Florida Department of Environmental Protection

December 4, 2008

RE: Post Source Removal Site Monitoring Plan for AOC 2, Letter from John Schoolfield, P.E., Naval Support Activity Panama City, Panama City Beach, Florida (NAVFAC SE, November 21, 2008)

Re: Panama City NAS AOC-2 Post Source Removal Site Monitoring Plan

Figure 1: Vent Well and Sample Locations 1-4

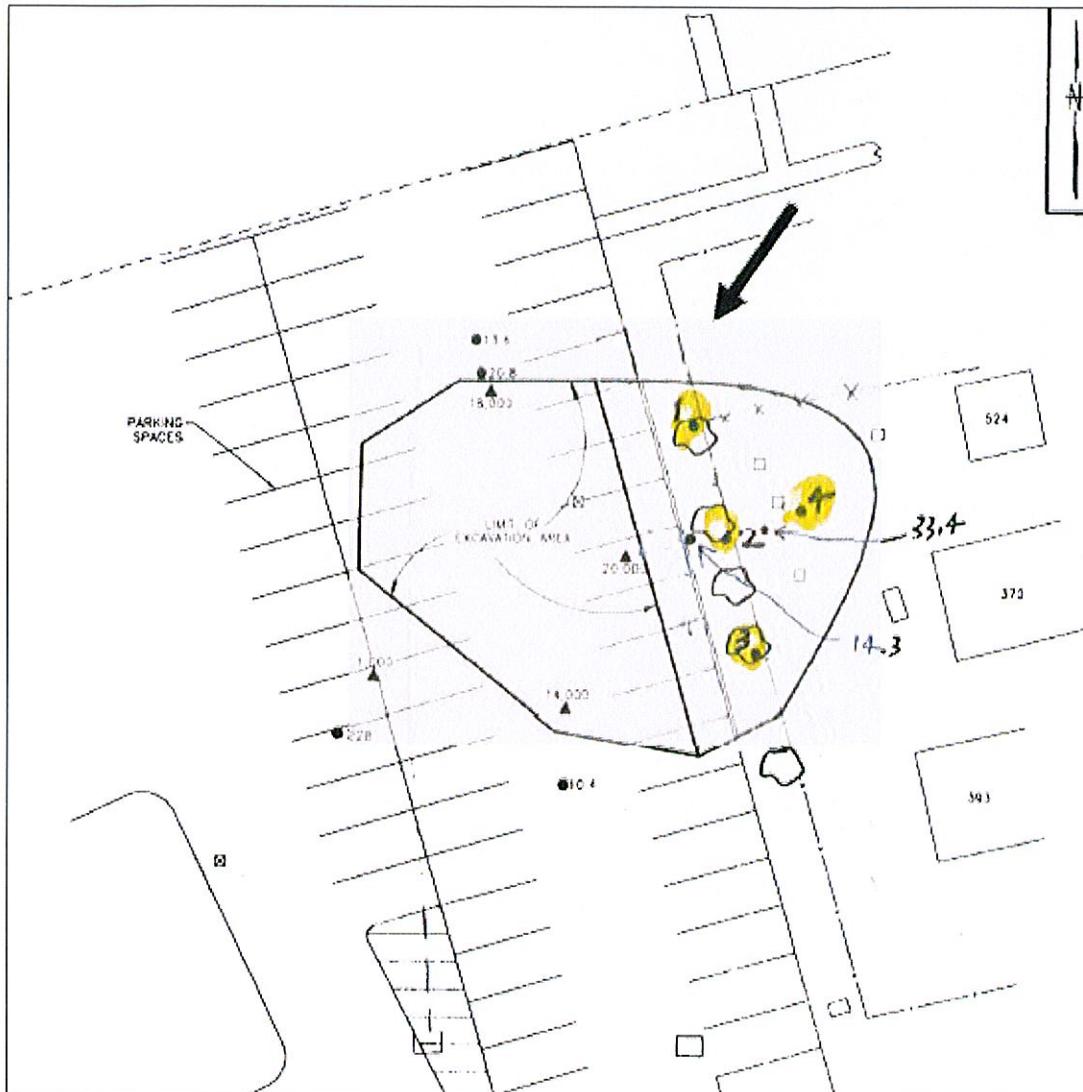
4. **Comment #4:** It is FDEP's opinion that, if soil samples are to be collected in the near future according to the Post Source Removal Site Monitoring Plan Letter, then they should be collected at all four locations listed in the letter presented by NAVFAC SE. Also, they should be collected as close to the water table as possible. The previous confirmatory soil samples collected by CH2M Hill after the excavation were collected between 4 and 4.5 feet below land surface (bls) (please review CH2M Hill's the Source Removal Report for AOC 2, October 2008). However, groundwater at this site is reported to be at approximately 6 feet bls. Future soil samples should be collected within the unsaturated zone as close to the water table as possible. FDEP defines the unsaturated zone as the dry portion of sediment above the water table elevation at the time that soil samples are collected. The two previous soil samples collected by CH2M Hill that are mentioned in this Post Source Removal Site Monitoring Plan Letter, and possibly all four samples, may have been collected at an elevation that was within, not at the bottom of, the unsaturated zone. Hence, the low concentration of TRPH that was found in them.
